LICENSE AUTHORITY FILE COPY  
UNITED STATES  
NUCLEAR REGULATORY COMMISSION  
WASHINGTON, D. C. 20555

The Commission has issued the enclosed Amendments Nos. 119, 119, and 116 to Licenses Nos. DPR-38, DPR-47 and DPR-55 for the Oconee Nuclear Station, Units Nos. 1, 2 and 3. These amendments consist of changes to the Station's common Technical Specifications (TSS) in response to your request dated November 12, 1982, as supplemented on February 24, 1983.

These amendments revise the TSS concerning the heatup, cooldown and inservice test limitations for the reactor coolant systems of each Oconee unit.

SAFETY EVALUATION BY THE OFFICE OF NUCLEAR REACTOR REGULATION

Figure 3.1.2-3A

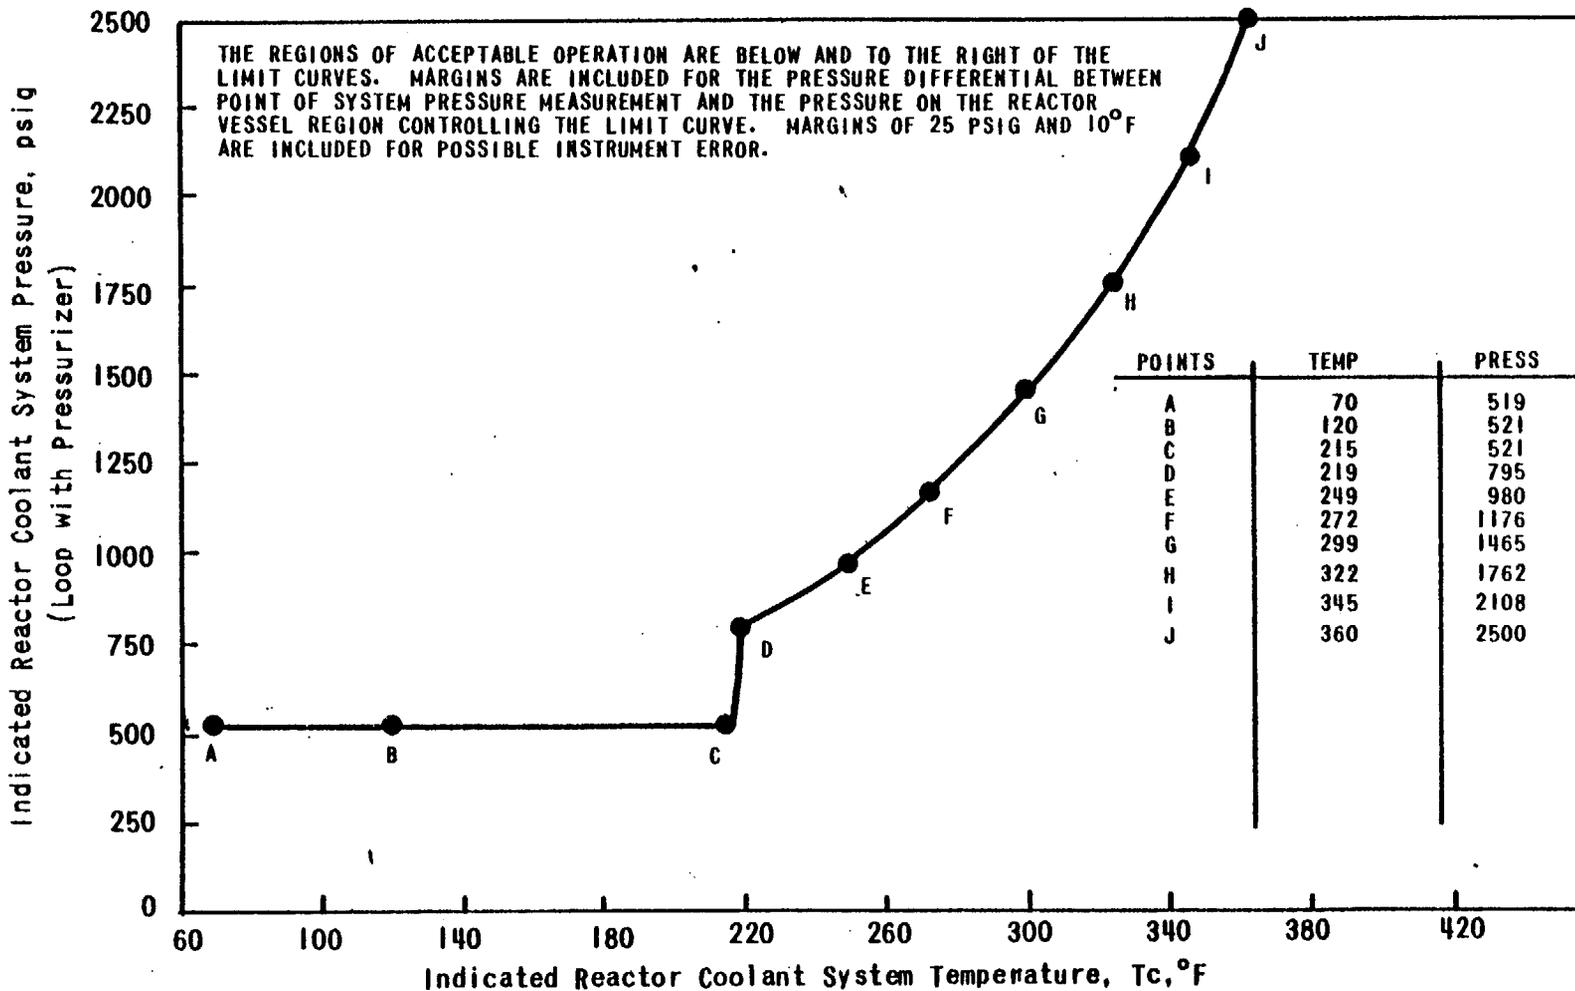
UNIT 1 OCONEE NUCLEAR STATION  
 REACTOR COOLANT SYSTEM INSERVICE LEAK AND  
 HYDROSTATIC TEST HEATUP AND COOLDOWN LIMITATION  
 APPLICABLE FOR FIRST 15.0 EFYP

- 3.1.2.2 Leak tests required by Specification 4.3 and ASME Section XI shall be limited to the heatup and cooldown rates and allowable combinations of pressure and temperature provided in Tables 3.1-1, 3.1-2 and Figure 3.1.2-3A Unit 1  
3.1.2-3B Unit 2  
3.1.2-3C Unit 3
- 3.1.2.3 For thermal steady state system hydro tests required by ASME Section XI the system may be pressurized to the limits set forth in Specification 2.2 and 3.1.2.2.
- 3.1.2.4 The secondary side of the steam generator shall not be pressurized above 237 psig if the temperature of the vessel shell is below 110°F.
- 3.1.2.5 The pressurizer heatup and cooldown rates shall not exceed 100°F/hr. The spray shall not be used if the temperature difference between the pressurizer and the spray fluid is greater than 410°F.

Figure 3.1.2-3B

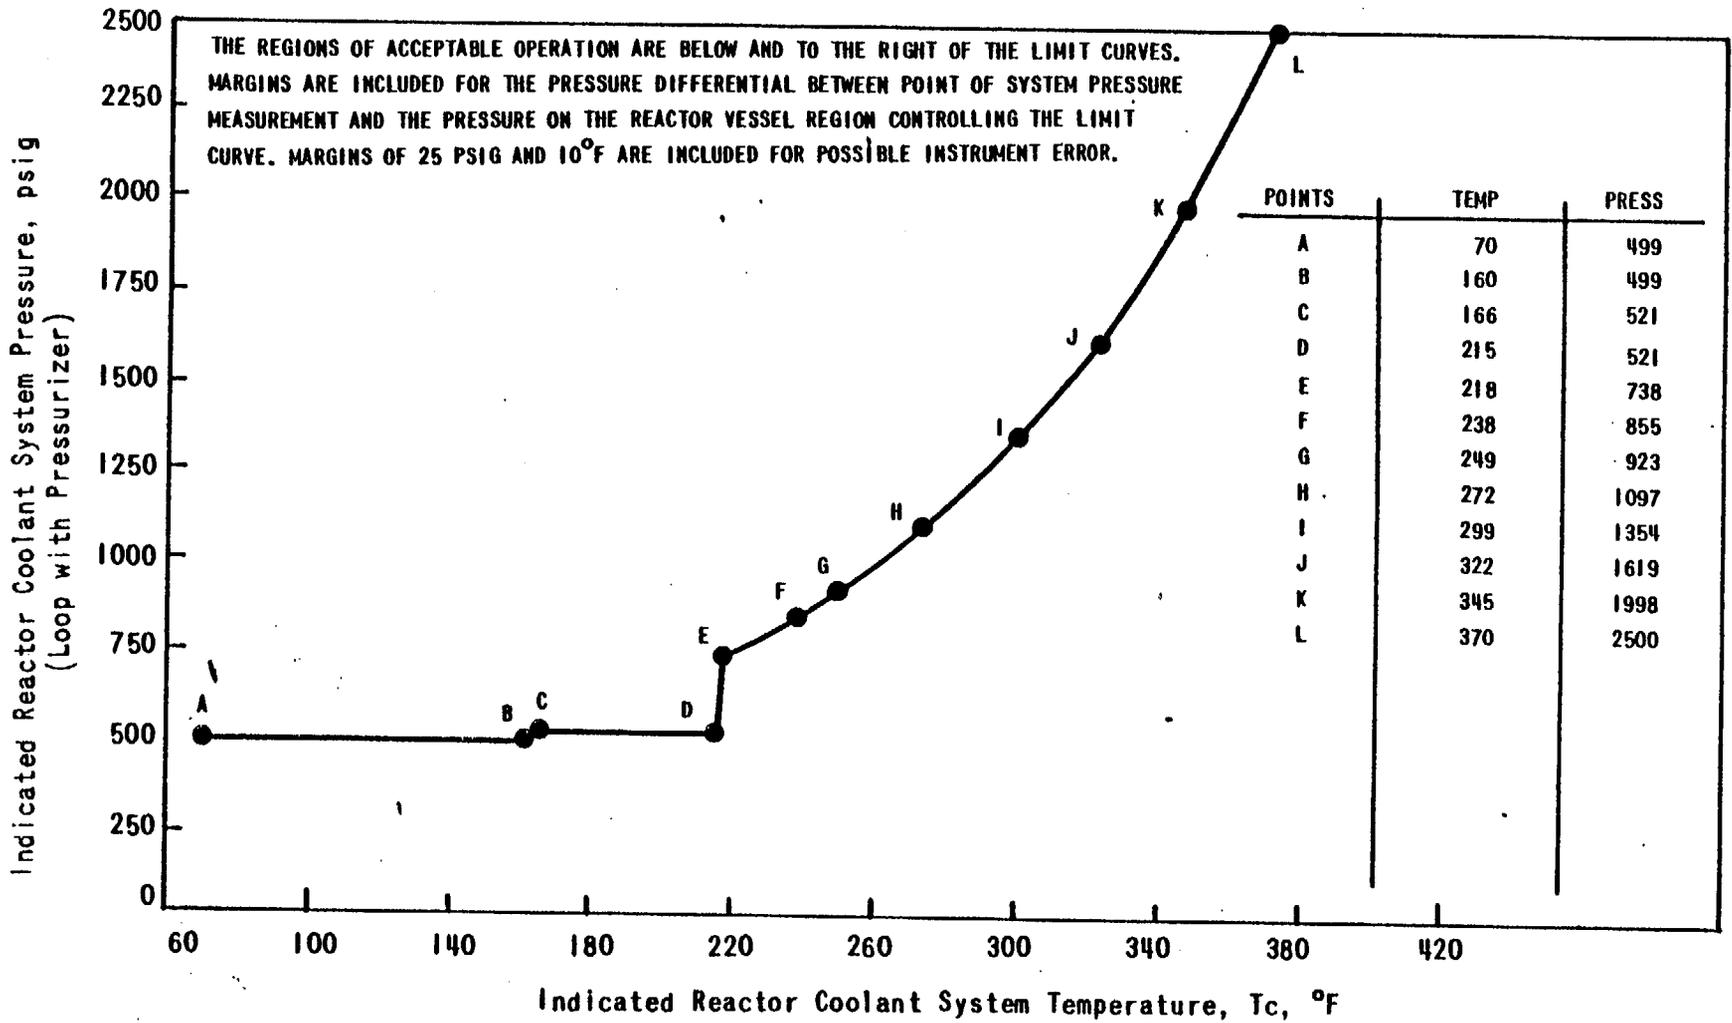
UNIT 2 OCONEE NUCLEAR STATION  
 REACTOR COOLANT SYSTEM INSERVICE LEAK AND  
 HYDROSTATIC TEST HEATUP AND COOLDOWN  
 LIMITATIONS APPLICABLE FOR 15.0 EFPY
